Report on Manor Park Estates Redevelopment

Comments and Concerns from Manor Park Community

Comments: Application #D01-01-21-0003 (Manor Park Estates)

Figure 2: Key Features of Current 5-Way Intersection

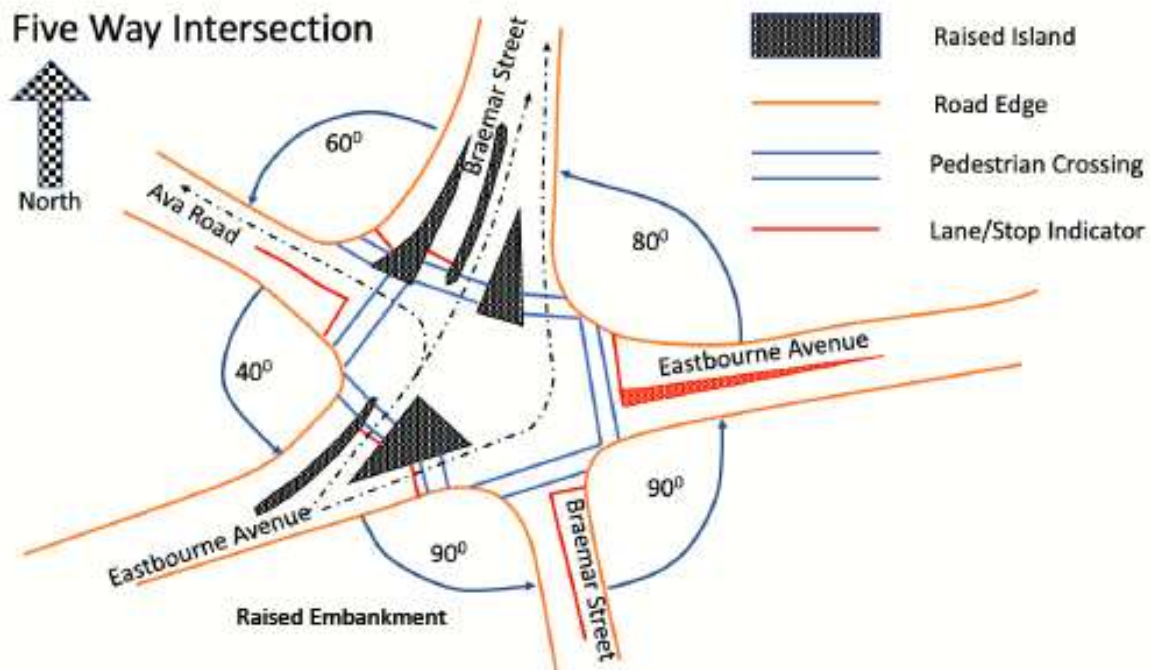
The intersection has a number of characteristics that are generally considered to be undesirable, and should be avoided if at all possible. Below is a schematic representation of the key features of the current intersection, showing the raised islands, pedestrian crossing and intersecting roads.

A second problem is the absence of sidewalks along Eastbourne Avenue, on the section between St. Laurent and the five-way intersection.

a) Multi-Leg and Multiple Lane Intersection Type

Multileg intersections are seldom used and should generally to be avoided if at all possible. They are sometimes found in urban areas where traffic volumes are light. Multiway intersections generate conflicting movements and impair safety and efficiency. The use and placement of the raised islands generate dual lanes exiting Braemar from the North, dual lanes exiting Eastbourne from the east and dual lanes when entering Braemar to the North. This creates confusion as to which lane is the correct one to use. For one example of the possible confusion, see the dashed arrows indication direction of travel and note that there are two possible lanes that could be seen to be entering Braemar from Eastbourne Avenue in Figure 2. Generally multiple lanes are not recommended for a multi-way intersection. The narrow islands become virtually impossible to see during the winter, creating very narrow lanes for egress and entry.
